MONTGOMERY COUNTY HISTORIC PRESERVATION COMMISSION
STAFF REPORT

Address:	7100 Sycamore Ave., Takoma Park	Meeting Date:	12/15/2021
Resource:	Contributing Resource Takoma Park Historic District	Report Date:	12/8/2021
Applicant:	Marc Pfeuffer	Public Notice:	12/1/2021
Review:	HAWP	Tax Credit:	partial
Permit No.:	973888	Staff:	Dan Bruechert
Proposal:	Front Porch Alteration, Rear Demolition, and Rear Deck Construction

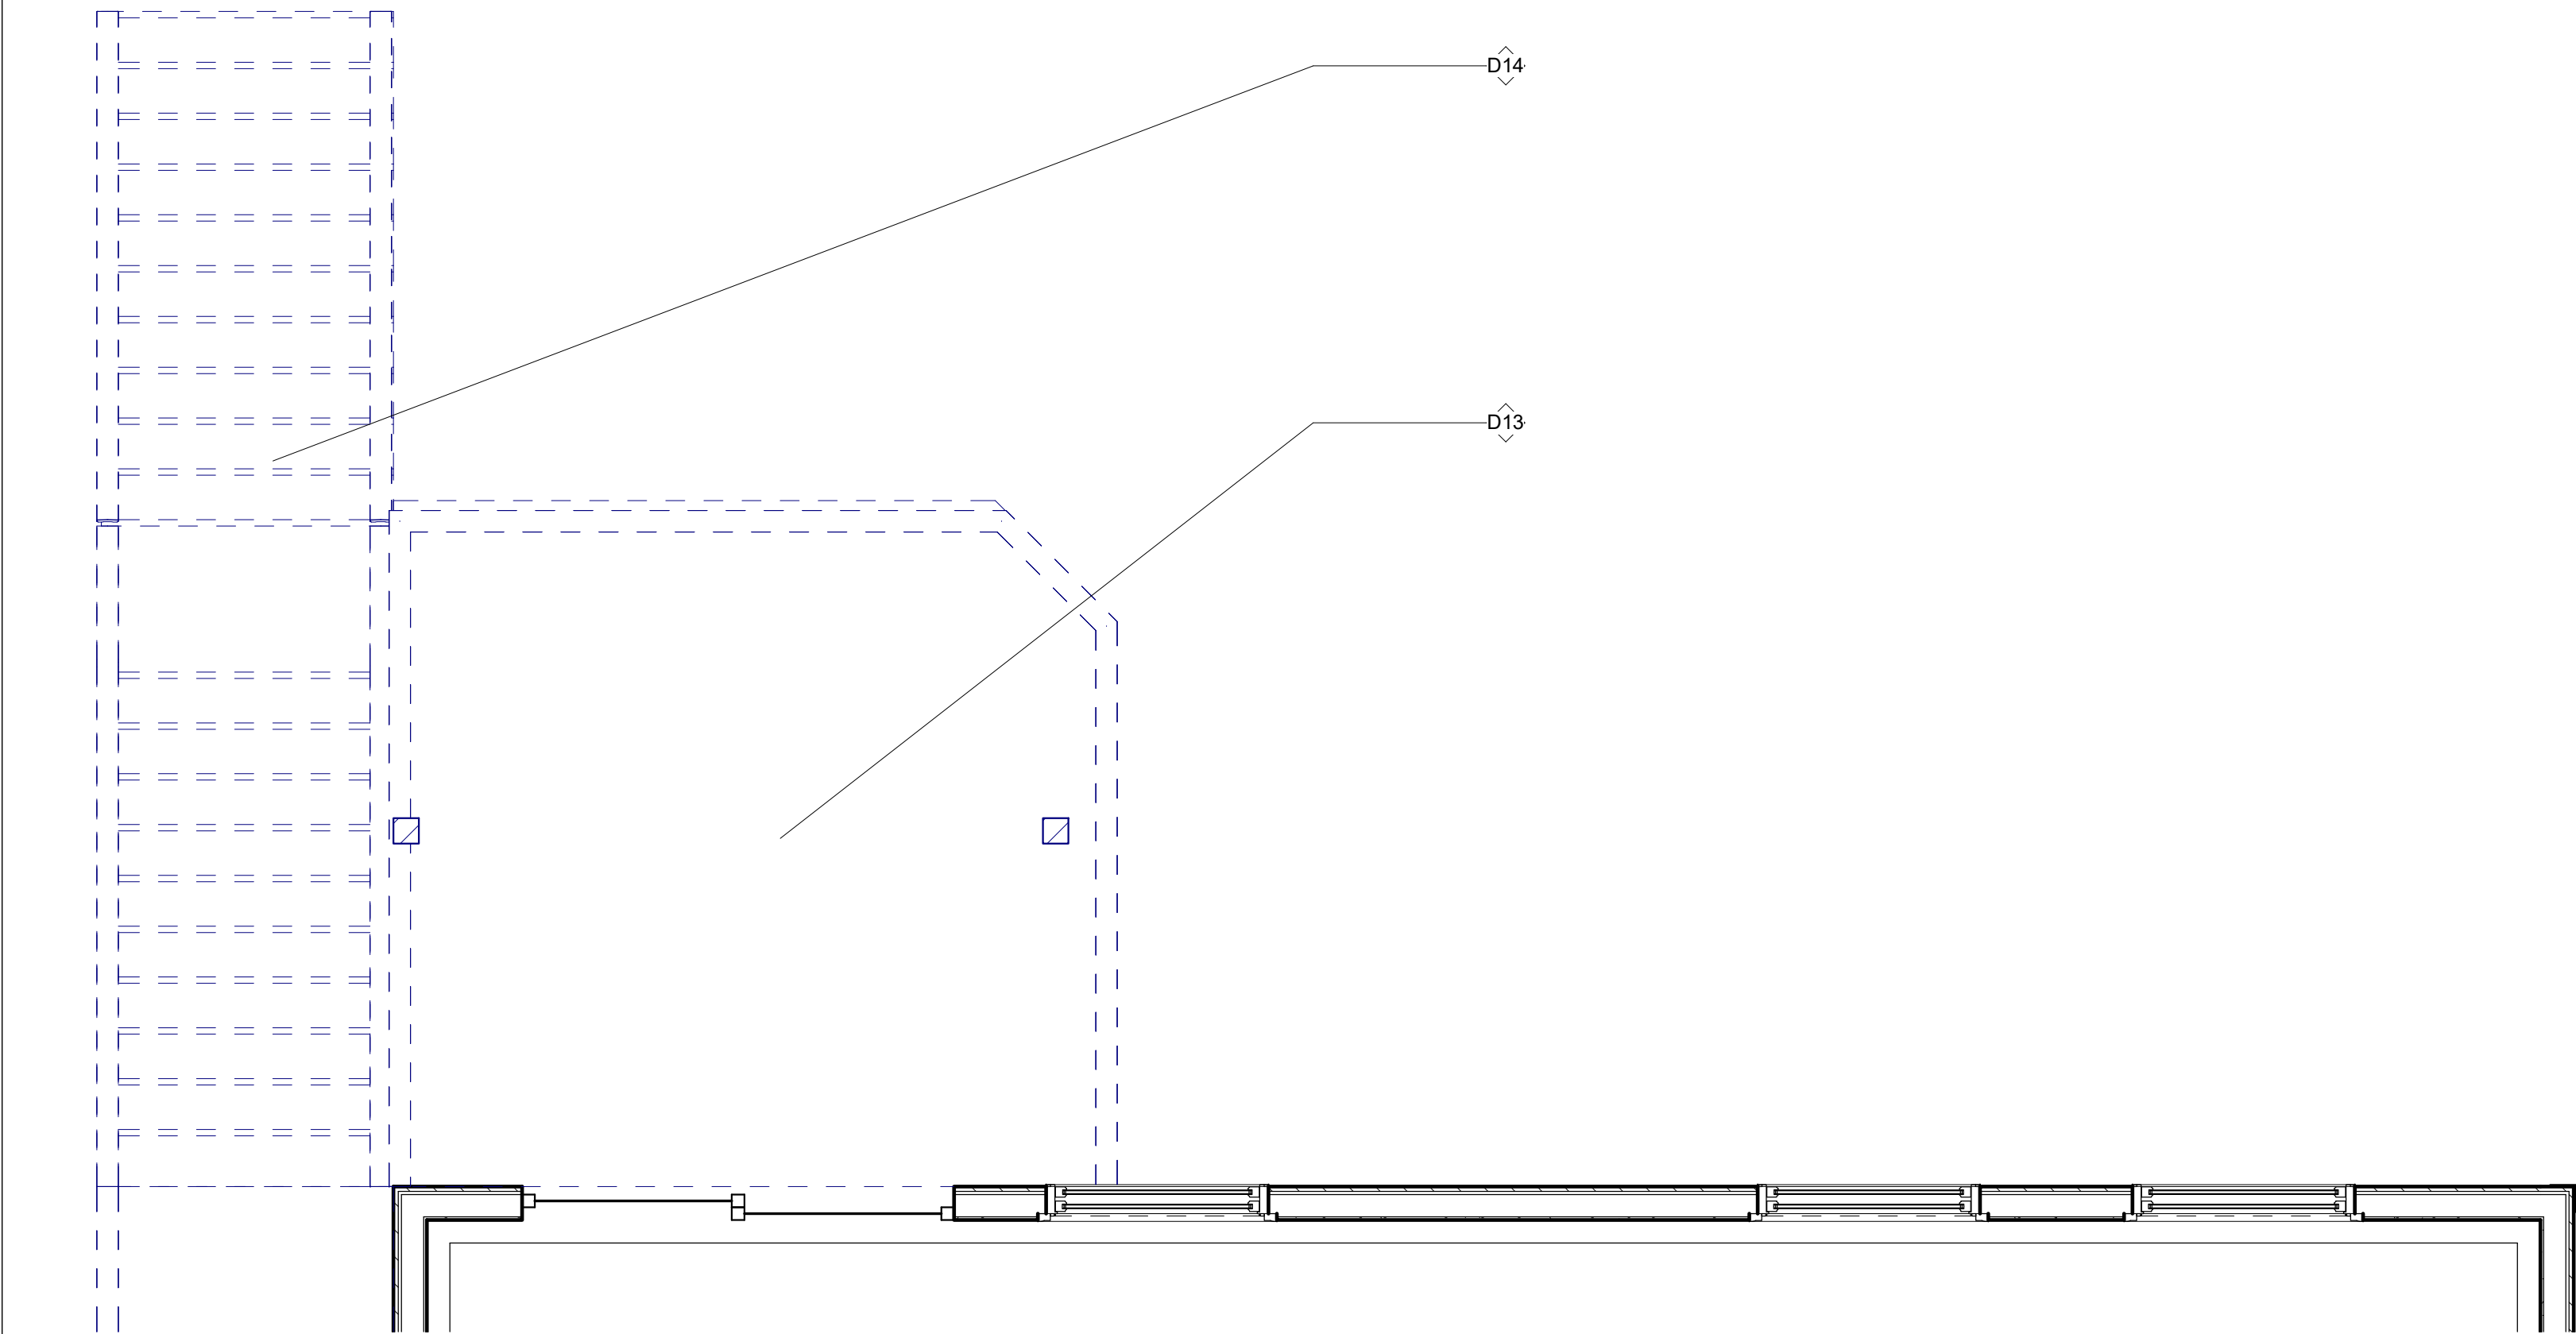
Staff finds that as a substitute feature, a new knee wall needs to blend into the house architecture and surrounding district. Staff does not find the proposed pressured-treated wood and aluminum balusters are architecturally compatible from either a design or material consideration. Pressure-treated wood typically cannot be painted and Staff finds that an unpainted finish would be inappropriate for the subject property. The proposed aluminum balusters would introduce an additional material on the front of the traditionally designed Craftsman house.

Staff finds that the proposed railing should replicate the appearance of the existing knee wall. This does not mean that the construction of a replacement knee wall needs to match the existing, only that the appearance does; meaning a skim coating on the wall with painted stone or concrete trim. This can be constructed in several ways and the Staff is primarily concerned with the exterior appearance and long-term preservation of the resource. Staff recommends the HPC include a condition to the approval of this HAWP that the replacement knee wall needs to match the exterior appearance and material of the existing condition and that plans that satisfy this condition need to be submitted to Staff for verification. Staff notes that because the appearance of the feature will be retained it is eligible for County Historic Preservation Tax Credits.

1. The proposed front porch railing is incompatible with the subject property and the surrounding district. The replacement railing/knee wall needs to match the appearance and dimensions of the existing. Drawings showing this condition has been satisfied need to be submitted to Staff to verify that this condition has been met final approval; and
2. The decking proposed for the front porch has to be wood. Final plans submitted to reflect the material requirement need to be submitted to Staff for final approval;
